1 **Review of Hillslope hydrology under glass: confronting fundamental questions of soil-water-**  
2 **biota co-evolution**

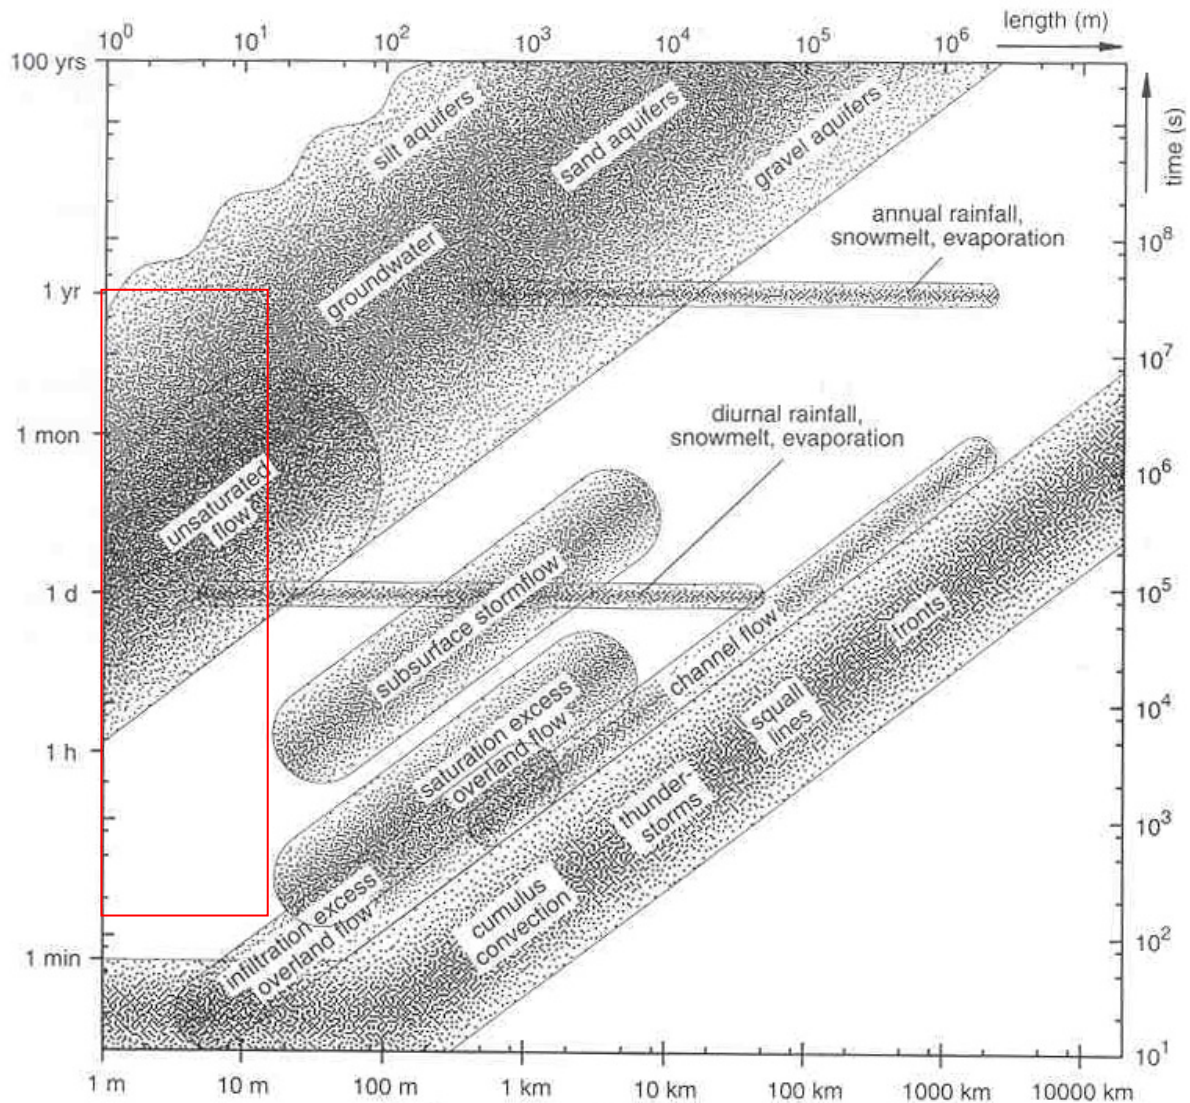
36  
37 A way to possibly help the community visualize the limitation imposed by the various design  
38 criteria is to place the design criteria within the context of a commonly used descriptive figure  
39 in hydrology

1  
 2 [Grayson and Blöschl, 2001] The Red box seems to me the domain that the hillslope will  
 3 operate within. Other design factors may further constrain or expand this region. A comment  
 4 from the authors about this would be appreciated.
